## **Board of Architectural Review**

DATE: September 04, 2013  
TO: Board of Architectural Review Chair and Members  
FROM: Mike Jaskiewicz, AICP, BAR Liaison *MJ*  
THROUGH: David Hudson, Director, Community Development & Planning *DH*  
Development Division Chief  
SUBJECT: 10341 Main Street (The Mayfair): review of proposal with the exception of off-site plantings.

1. Case Number: 634-13-3T (13070014)
2. Address: 10341 Main Street (The Mayfair)
3. Request: Review and approve the architecture and site design of the Council-approved 25 dwelling units and associated facilities on the subject site located at 10341 Main Street.
4. Applicant: Fairfax Main Street LLC
5. Applicant's Representative: Molly Novotny
6. Status of Representative: Agent
7. Zoning: C-2 Retail Commercial, Transition Overlay District (TOD)

# The Mayfair

RENDERED SITE PLAN

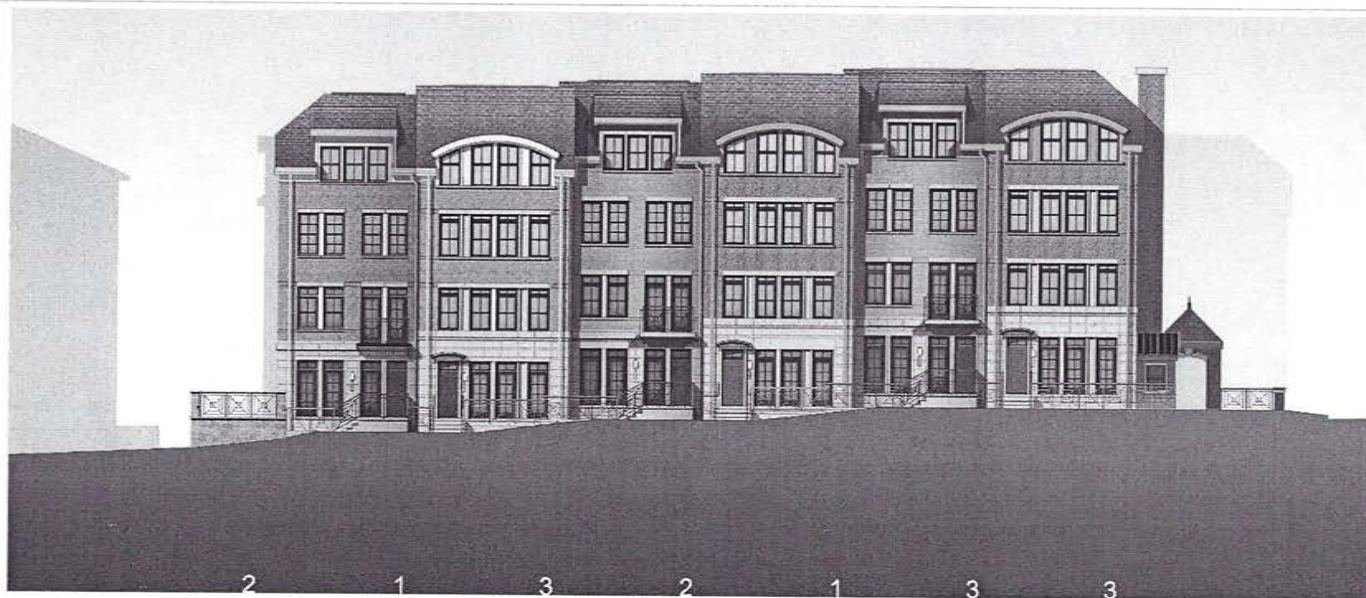
2. Sheet A.201: Rendered Site Plan. The applicant has purposefully not provided an indication as to the configuration of the previously-approved open rooftop patios facing the interior of the subject site.
